**RE: CREEKVIEW APARTMENTS AT WOODLAND PARK – PHASE 2**  
**SITE PLAN REVIEW**  
**TAX MAP No. 84.00-1-44.200**  
**CPN No. 20-016**  
**MRB PROJECT No.: 0300.12001.000 PHASE 195**

MRB has completed a review of the submitted Site Plan regarding the above referenced project, dated March 13, 2020, prepared by BME Associates. We offer the following comments for the Planning Board's consideration. A brief written response to each comment should be provided by the design engineer.

# TYPICAL UTILITY SERVICE PLAN

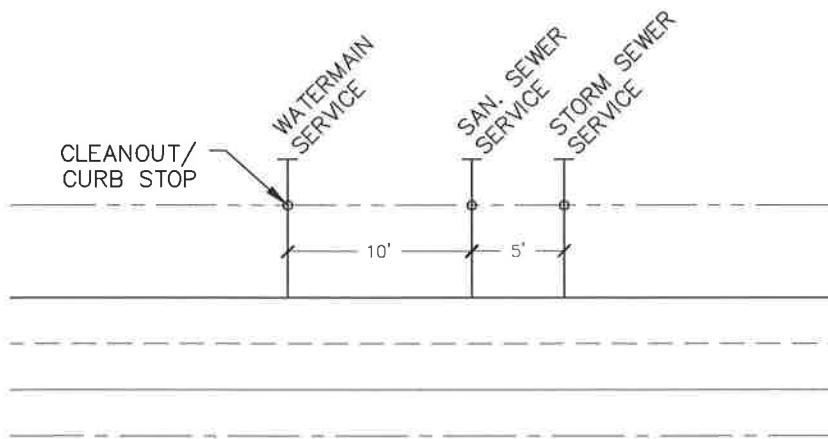
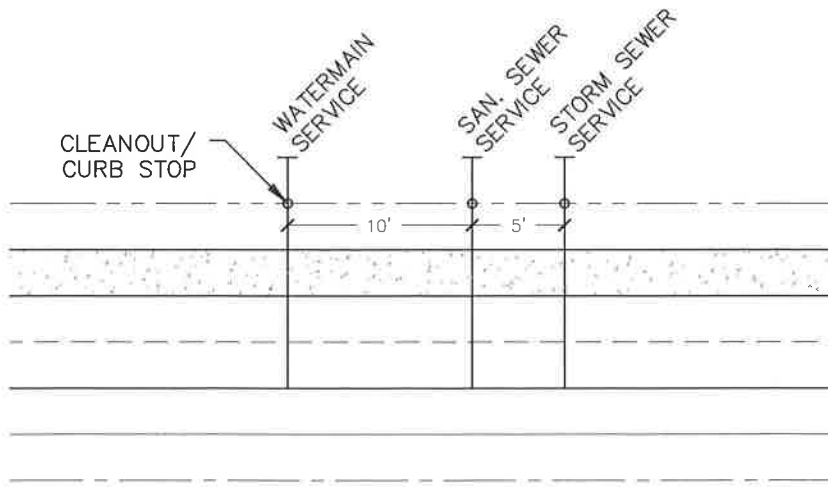
- a. Typical Water Service
  - b. Watermain pressure test
  - c. Dead end hydrant (if any are proposed)
  - d. Pavement Cross Section (for paving within any right of ways)
